DEVELOPMENT REVIEW COMMITTEE (DRC) COMMENT REPORT

CGM Group, LLC / Los Patios

Case Number: R15059

Request: Townhouse Units

SP-1

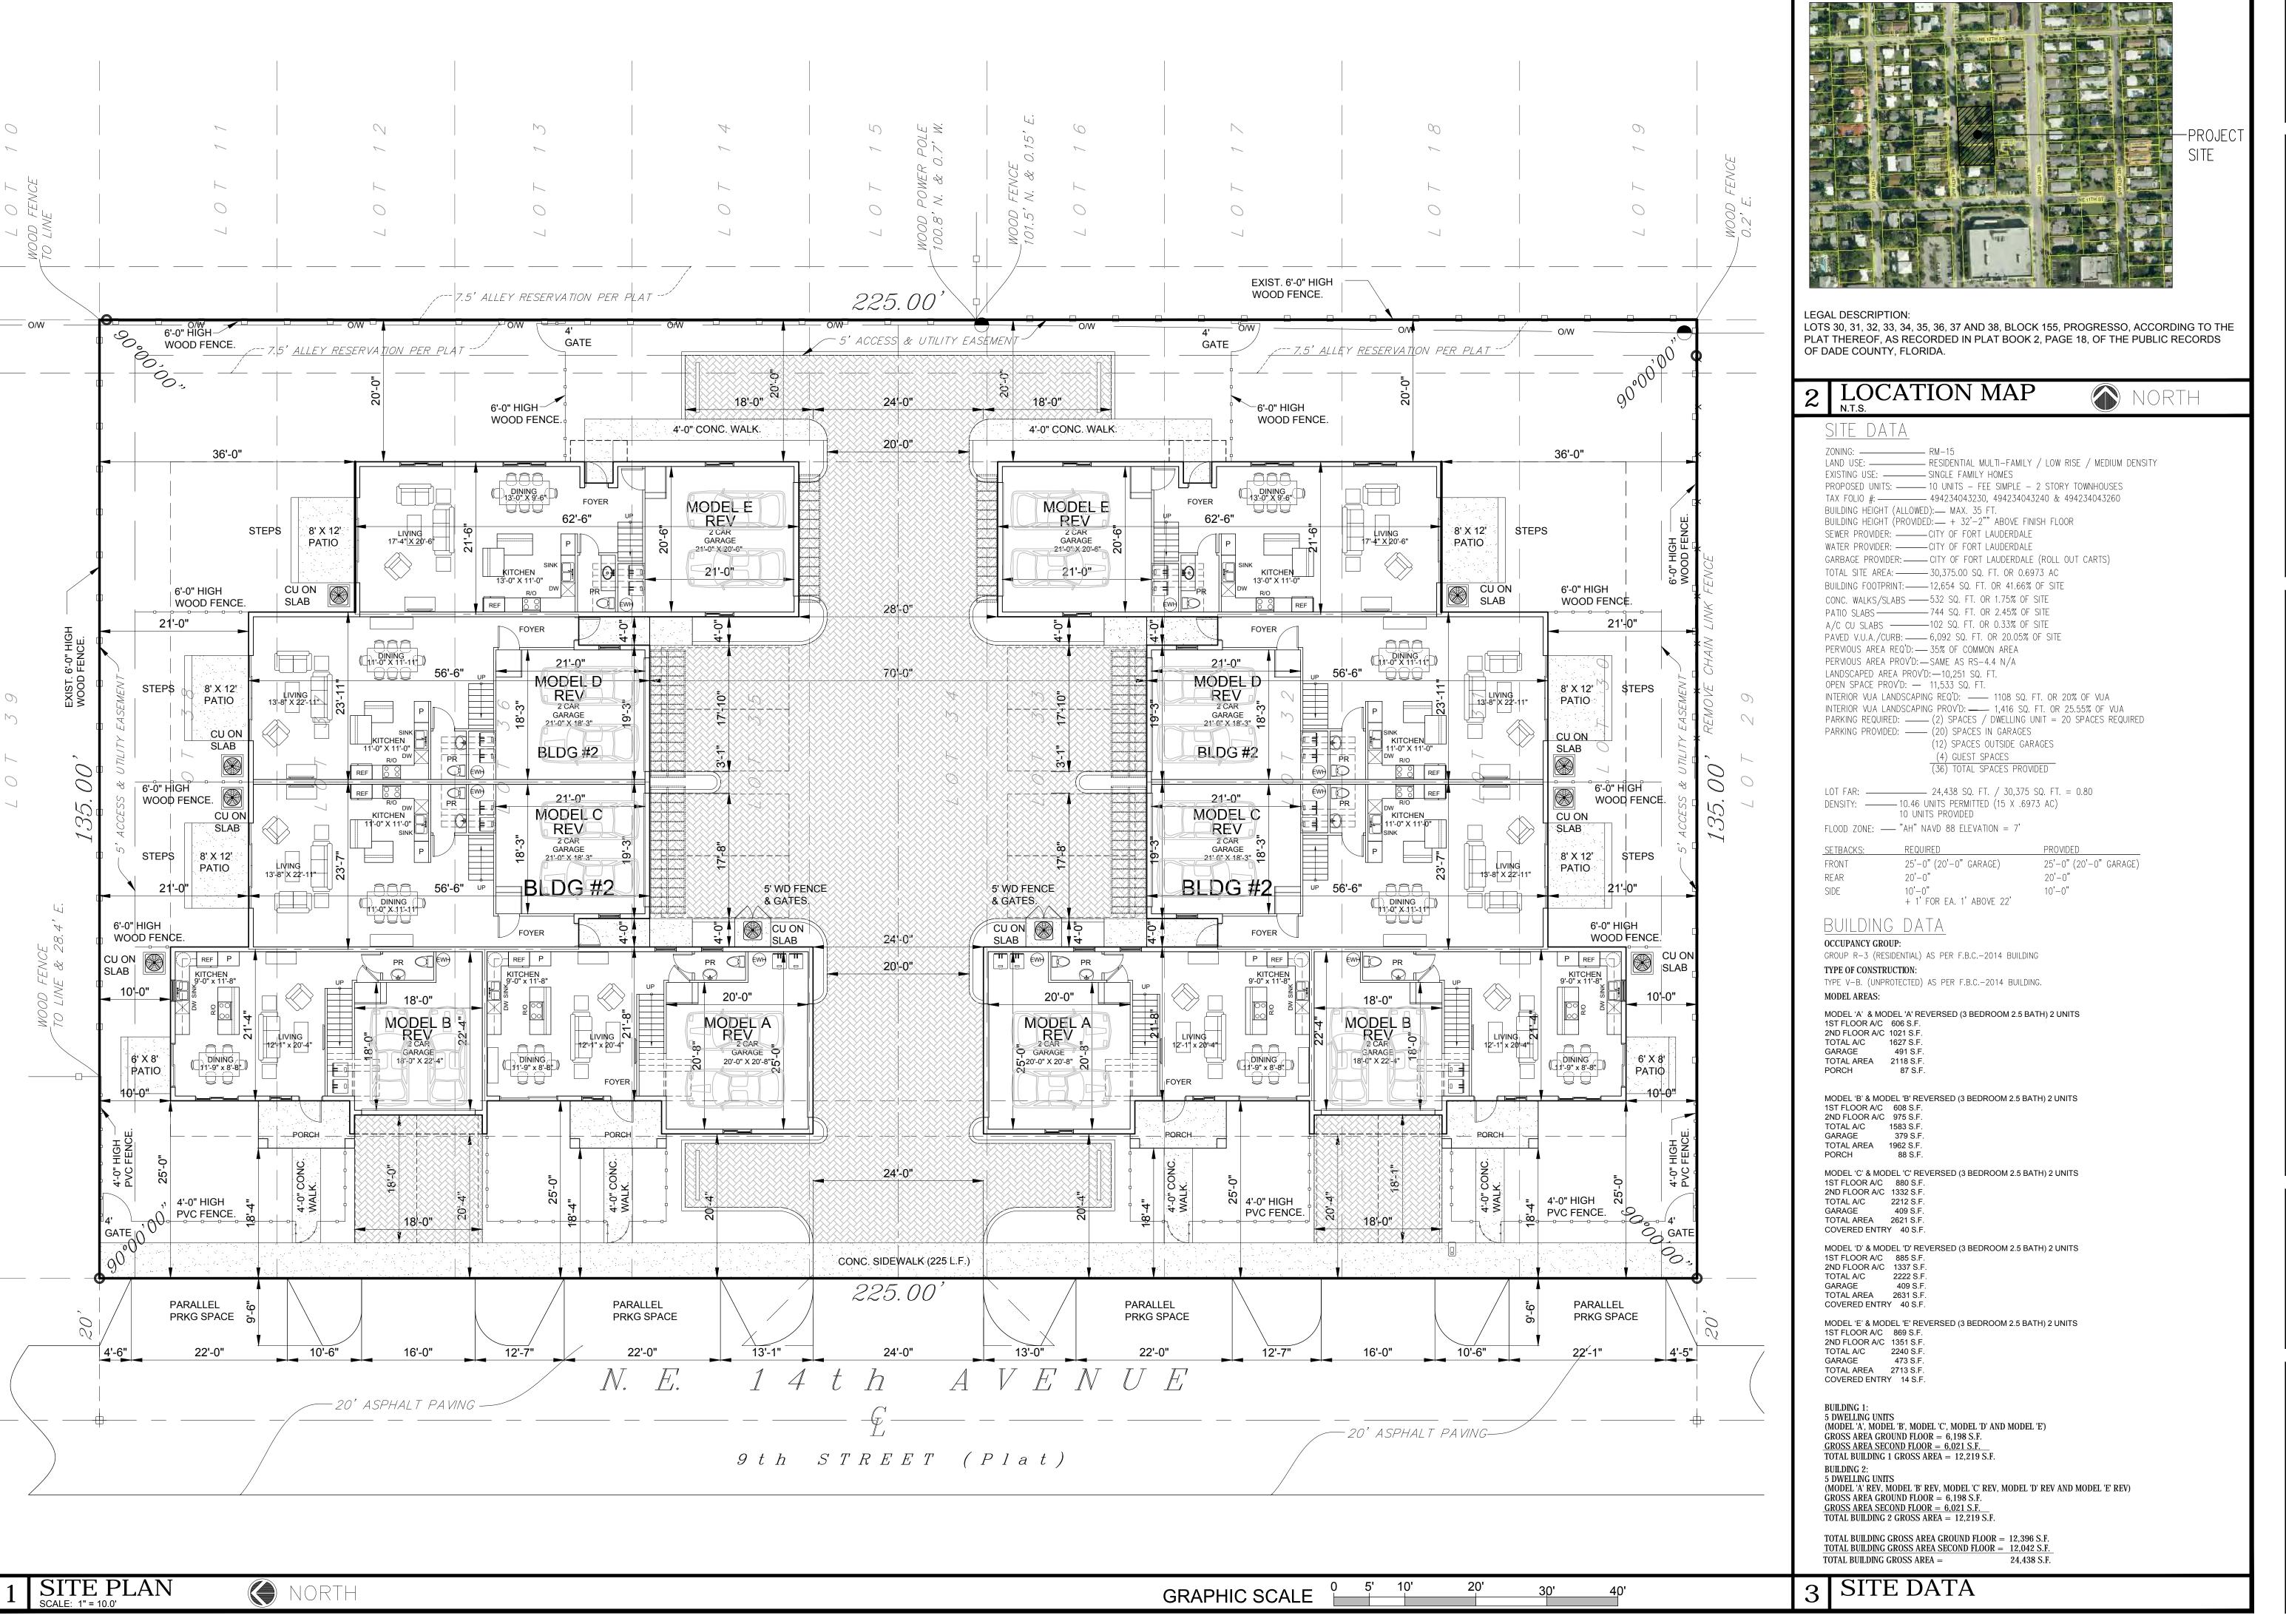
- 4. Show and callout delineations for proposed Right-of-Way Easement boundaries on the Site Plan and the Civil drawings.
- 5. Consider reducing proposed driveway width to the minimum 18' for two-way travel access, per ULDR Section 47-20.5.C.3.a.ii, especially to accommodate on-street parallel parking and allow for clear sight triangle visibility.

- 7. Per ULDR Section 47-2.2.Q, show and label sight triangles as appropriate for safe and adequate access of drivers and pedestrians, on the Site Plan, Landscape Plans, and Civil Plans: intersections of driveways with streets (measured from pavement edges), alleys with alleys (measured from property lines extended), alleys with streets (measured from property lines extended), and streets with streets (measured from property lines extended). Per ULDR Section 47-19.1.E, no accessory use or structure shall be permitted within a sight triangle except as provided in ULDR Section 47-35.

LEFT SIDE (NORTH) ELEVATION - BLDG 1
SCALE: 3/16" = 1'-0"

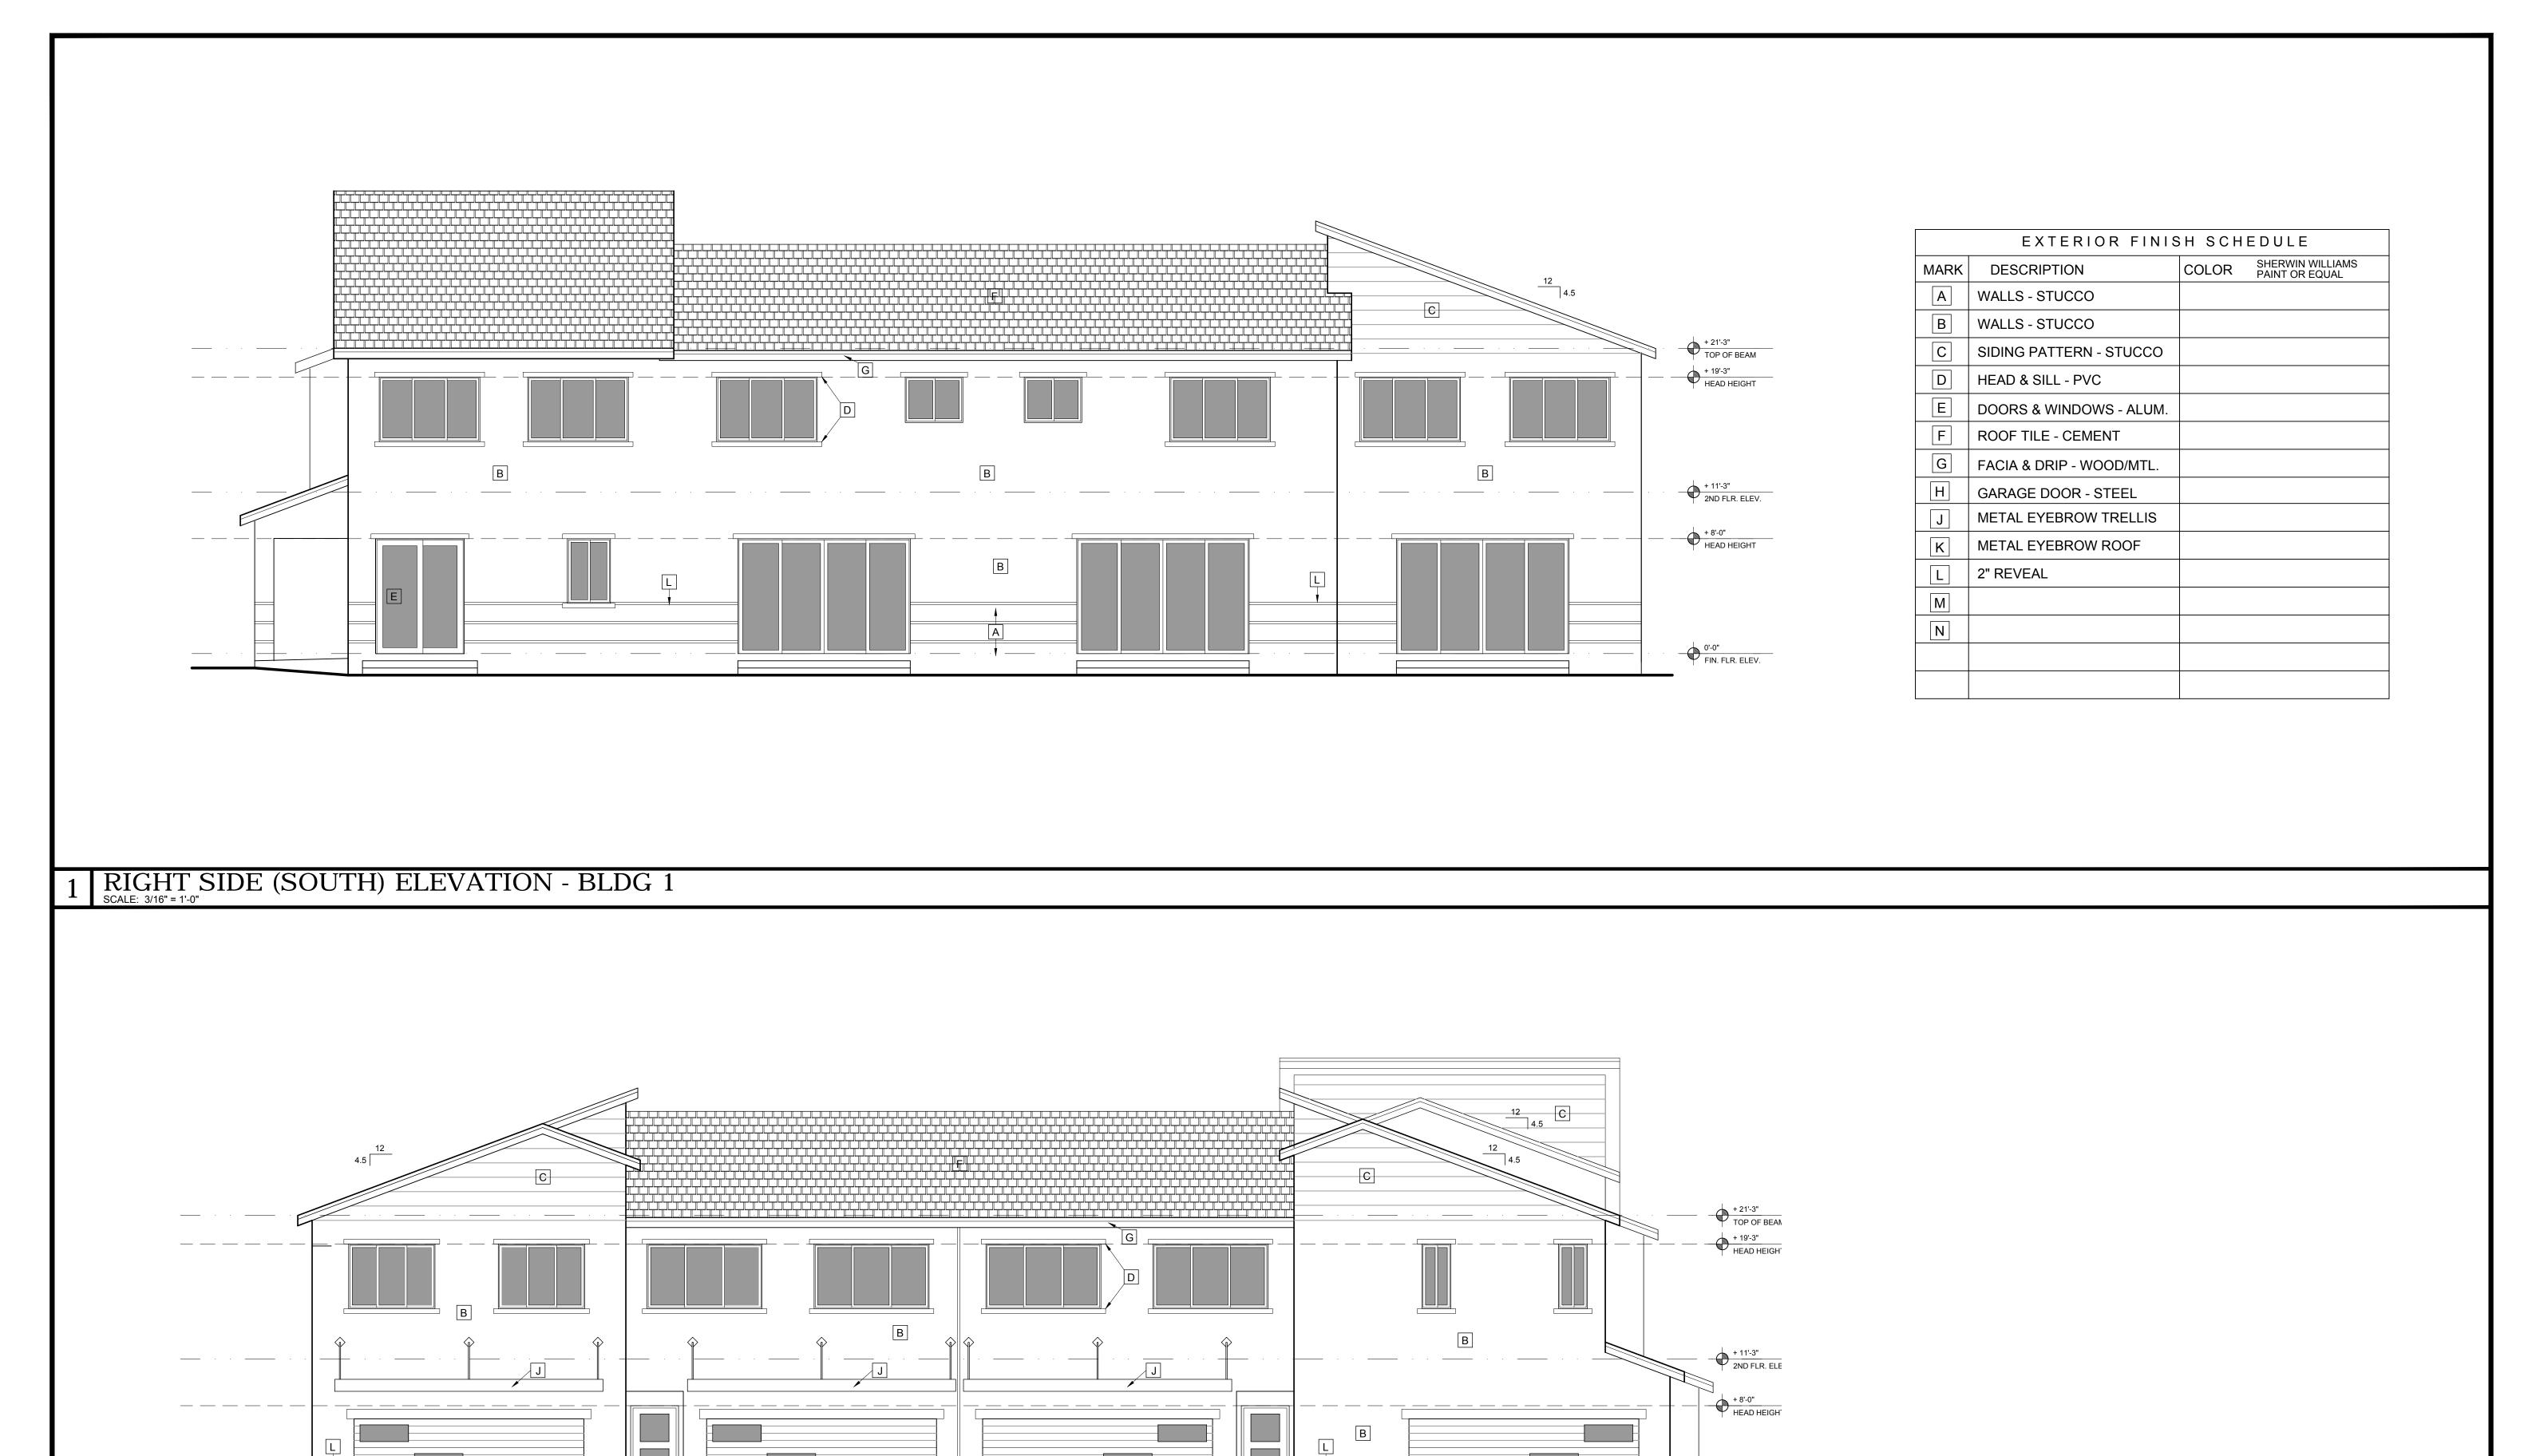
- d. Provide dimensions on the north and south facades to indicate the highest point of the roof and to clarify how the portion of the structure that exceeds 22 feet in height is setback 1 foot for each foot of height;
